SUPPLEMENT #2 TO THE TECHNICAL DRAINAGE STUDY

Sunrise & 28th Multi-Family Residential

MCH-24-001

SUPPLEMENT #2 TO ADDENDUM #2 to the Technical Drainage Study for Sunrise & 28th
JURISDICTION JOB #L24-02473

FIGURE 7

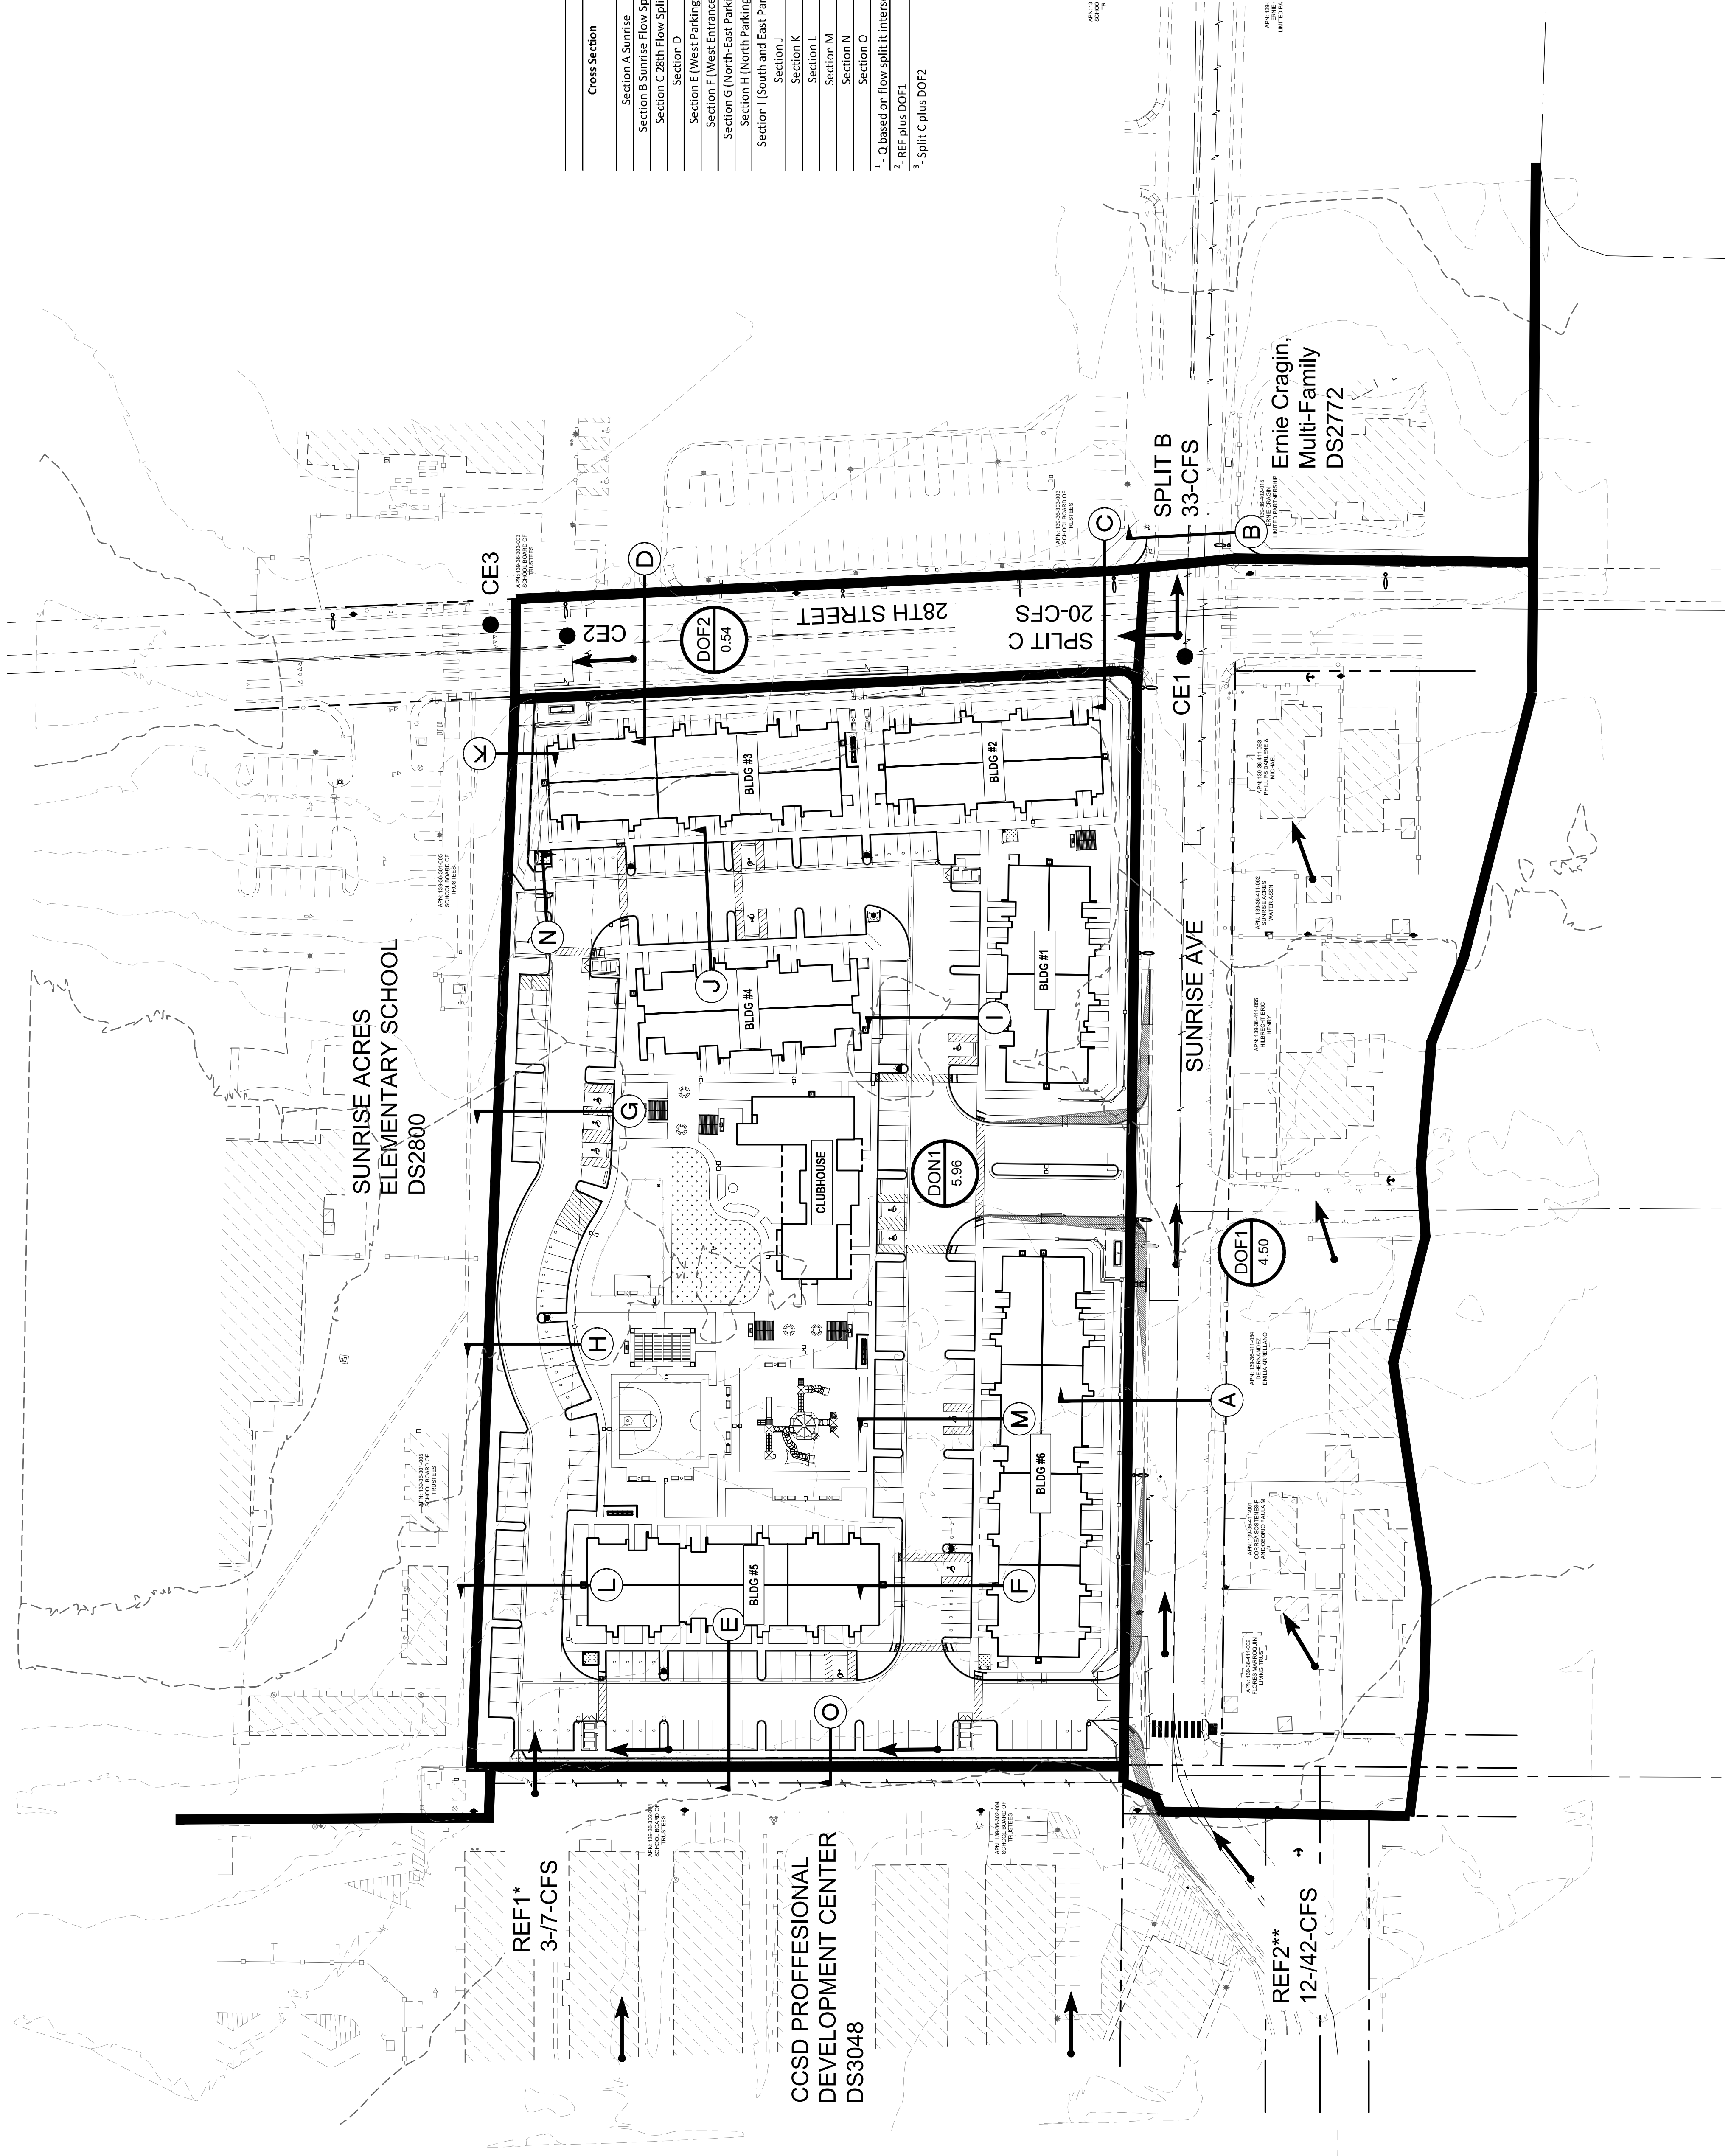
Taney Engineering is submitting Supplement #2 to Addendum #2 in response to an email correspondence for the Technical Drainage Study for **Sunrise & 28th**. The changes to the grading are in the South and East parking areas. The top of curb grades in these areas have been revised to accurately reflect the transitions from A-curb to Zero Lip curb. These changes range from raising top of curb grades by 0.5' to lowering a top of curb grade by 0.53'. Grades near the maintenance shed were changed to prevent ponding in the area. In addition, an extra parking stall was added in the South parking area. The changes that were made did not have any impact on Finish Floors, Volumes, flow patterns, velocities, or normal depths.

Cross Section	Ultimate Condition					
	Description	Q (cfs)	Slope (%)	Depth (ft)	Velocity (ft/s)	DxV
Section A Sunrises	DOF1-REF1	53	1.52	0.61	4.15	2.53
Section B Sunrises Flow Split	Footnote 1	33	1.25	0.56	3.51	1.97
Section C 28th Flow Split	Footnote 1	20	0.5	0.56	2.21	1.24
Section D	CE2	22	0.6	0.55	2.42	1.33
Section E (West Parking)	DON1	16	2.00	0.27	3.04	0.82
Section F (West Entrance)	DON1	16	1.3	0.34	3.98	1.35
Section G (North-East Entrance)	REF1 + DON1	23	0.69	0.38	3.19	1.21
Section H (North Parking)	REF1 + DON1	23	0.91	0.42	3.81	1.60
Section I (South and East Parking)	DON1	16	1	0.31	3.31	1.03
Section J	DON1	16	0.5	0.35	2.55	0.89
Section K	REF1+DON1	23	0.5	0.49	4.71	2.31
Section L	REF1+DON1	23	0.7	0.38	3.2	1.22
Section M	DON1	16	1.32	0.30	3.67	1.10
Section N	REF1+DON1	23	0.5	0.38	4.08	1.55
Section O	REF1	7	0.5	0.45	4.07	1.83

Cross Section for DETAIL F 100 YR Supp 2

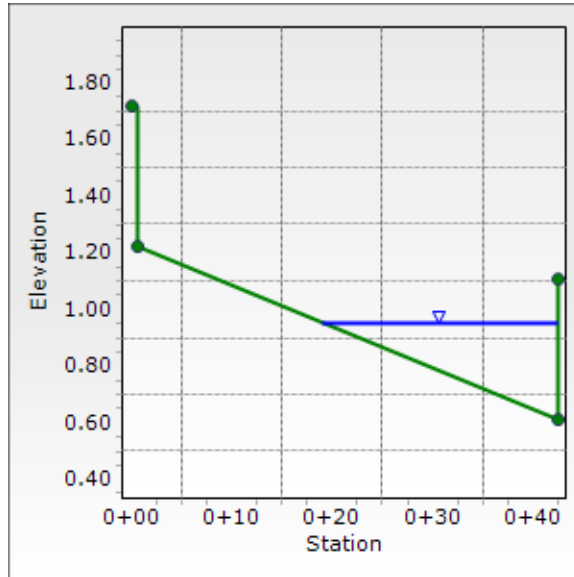
Worksheet for DETAIL F 100 YR Supp 2

Normal Depth	0.34 ft
Roughness Coefficient	0.013
Elevation	0.95 ft
Elevation Range	0.61 to 1.72 ft
Flow Area	4.02 ft ²
Wetted Perimeter	23.87 ft
Hydraulic Radius	0.17 ft
Top Width	23.53 ft
Normal Depth	0.34 ft
Critical Depth	0.42 ft
Critical Slope	0.4216 %
Velocity	3.98 ft/s
Velocity Head	0.25 ft

Cross Section for DETAIL I 100 YR Supp 2

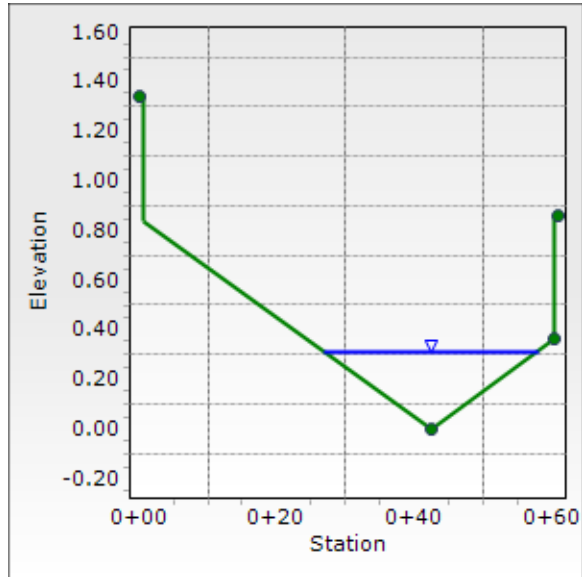
Worksheet for DETAIL I 100 YR Supp 2

Results	
Normal Depth	0.31 ft
Roughness Coefficient	0.013
Elevation	0.31 ft
Elevation Range	0.00 to 1.34 ft
Flow Area	4.84 ft ²
Wetted Perimeter	31.12 ft
Hydraulic Radius	0.16 ft
Top Width	31.11 ft
Normal Depth	0.31 ft
Critical Depth	0.36 ft
Critical Slope	0.4343 %
Velocity	3.31 ft/s

Cross Section for DETAIL M 100 YR Supp 2

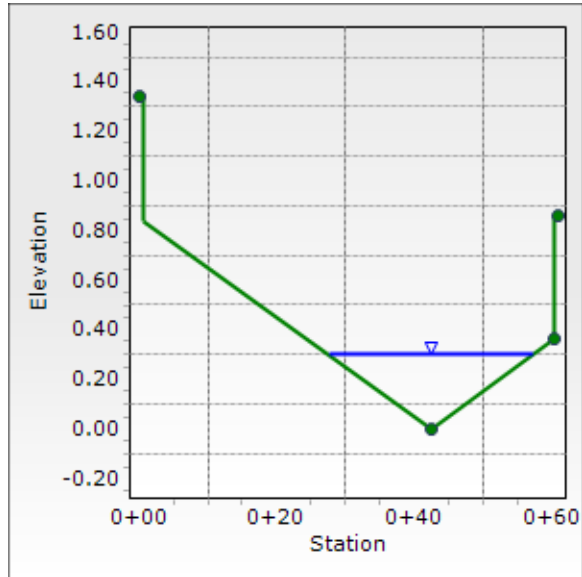
Worksheet for DETAIL M 100 YR Supp 2

Results	
Normal Depth	0.30 ft
Roughness Coefficient	0.013
Elevation	0.30 ft
Elevation Range	0.00 to 1.34 ft
Flow Area	4.36 ft ²
Wetted Perimeter	29.54 ft
Hydraulic Radius	0.15 ft
Top Width	29.54 ft
Normal Depth	0.30 ft
Critical Depth	0.36 ft
Critical Slope	0.4342 %
Velocity	3.67 ft/s
